From: Jordan, Richard
Sent: Monday, August 08, 2016 1:01 PM
To: 'Moeller, Roger (DEP)'
Cc: Marni Carroll; Jackson, Rob; Spieler, Richard (DEP)
Subject: RE: Titcomb Landfill Solar Project (X269745)
Attachments: SW_Pre_Post_update-POST.PDF

TITCOMB LANDFILL

POST DEVELOPMENT STORMWATER ANALYSIS

SW-2.0

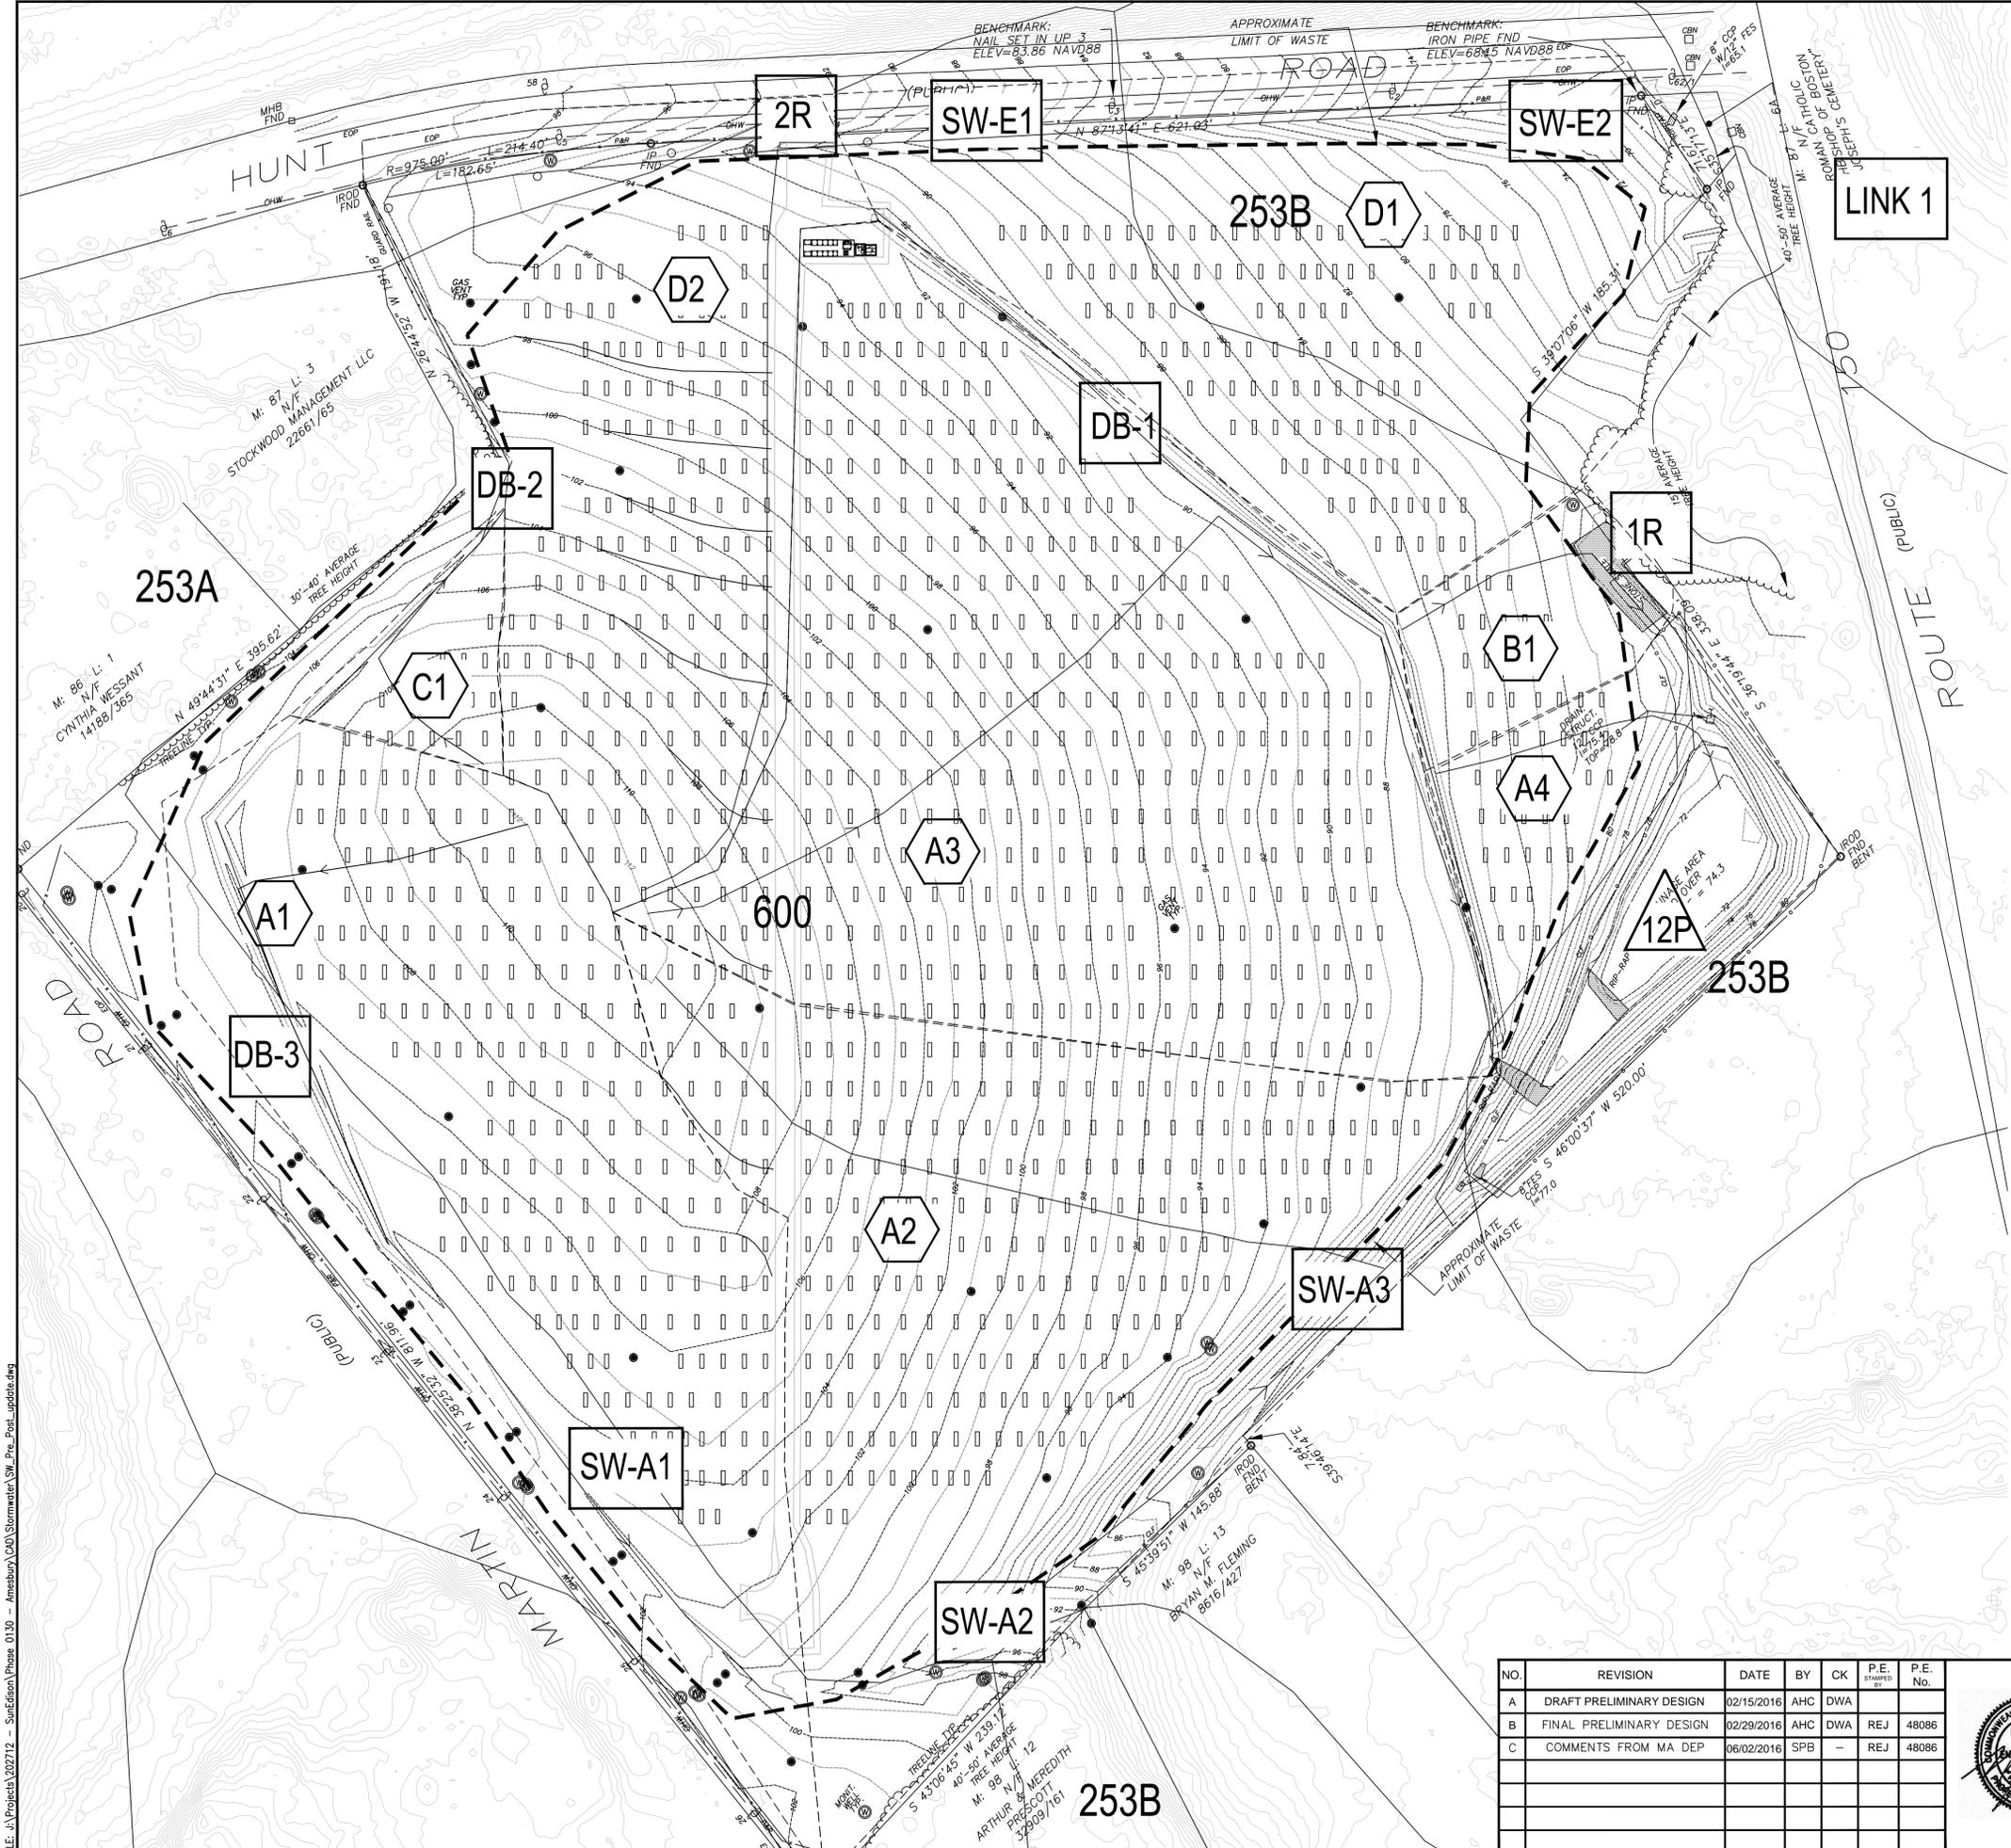
Thank you for the submitting the requested additional information, looks like you had a late Sunday night doing so. I did a cursory review of the additional information and it looks like a revised Sheet SW-2.0 "Post Development Stormwater Analysis", which should show the revised drainage basin layout, still needs to be submitted in order to complete the BWPSW36 application review. Please submit at your earliest convenience and then the technical review will be restarted.

- 1) A review of Sheet C-5 "Grading Plan" shows a proposed permanent access road and associated grading such that areas upslope of the proposed access road will be graded towards or parallel to the proposed access road. A review of Sheet SW-2.0 "Post Development Stormwater Analysis" does not include the grading upslope of the permanent access road as shown on Sheet C-5. Per our conversation the project will include grading upslope of the permanent access road as shown on Sheet C-5. The proposed access road and grading appears to affect existing stormwater runoff pathways and should be modeled in the post development stormwater analysis. Please revise and resubmit Sheet SW-2.0 and relevant post development stormwater analysis calculations to include the proposed access road and grading. If time permits, it would also be helpful to revise Sheets C-2 and C-3 to show proposed final grades instead of existing and resubmit.

Here is the revised sheet SW-2.0. Let me know if this fits the spot and if you have any questions/needs.

- *TRC revised the "Post Development Stormwater Analysis" to include the grading upslope of the permanent access road, as shown on Sheet C-5, and made changes to other relevant sheets associated with the revised analysis.*
